**REMARKS**

Application No. 10/823,713  
Amendment dated August 4, 2005  
Reply to Office Action of May 5, 2005  
Annotated Sheet Showing Changes

FIG. 7A

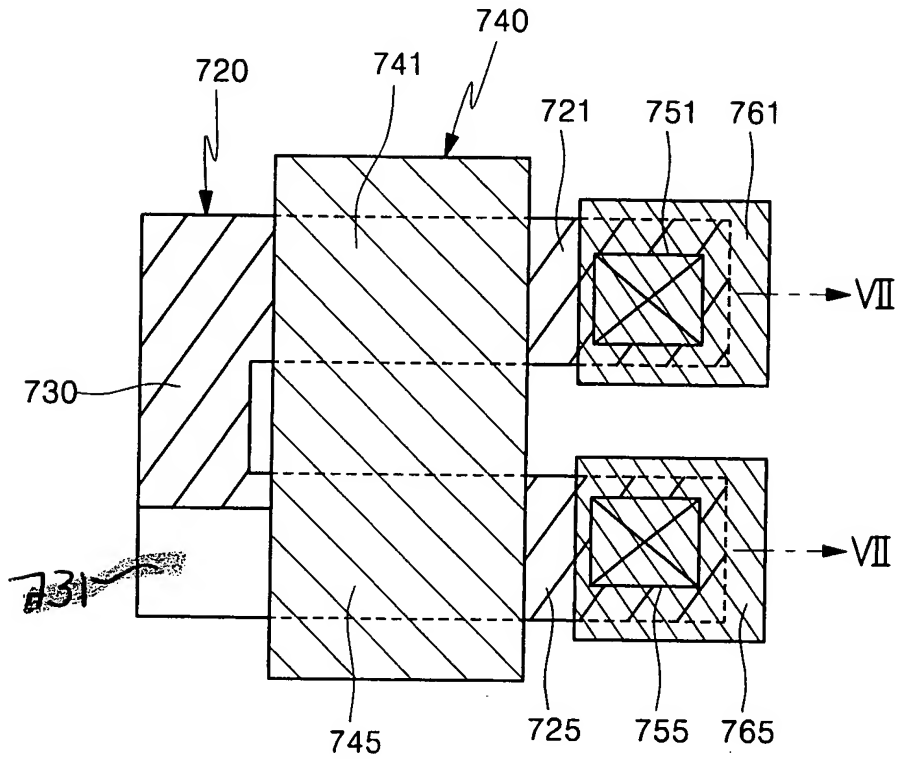
On page 2, numbered paragraph 2 of the Office action, the Examiner objected to Fig. 7A of the drawings because the "bottom left corner of Fig. 7A has not been labeled and it is not clear whether it is part of the drawing." To resolve this objection, Applicants have amended the drawing and provided a replacement drawing sheet in compliance with 37 CFR 1.121(d).

On page 3, numbered paragraph 2 of the Office action, the Examiner objected to Fig. 6 and Fig. 7 because they do not include reference numerals 661, 665, and 321, which are mentioned in the description.

Applicants amended Fig. 7A to include reference numeral 731 referring to the bottom left corner of Fig. 7A, which is a void area in the zigzag shape of the offset 730.

Applicants amended Fig. 7B to include reference numeral 731 at two locations related to the offset 730, which are void areas in the zigzag shape of the offset 730.

Applicants amended Fig. 7B to correct a clerical mistake to change reference numeral 321 to reference numeral 721, which is mentioned in the description.
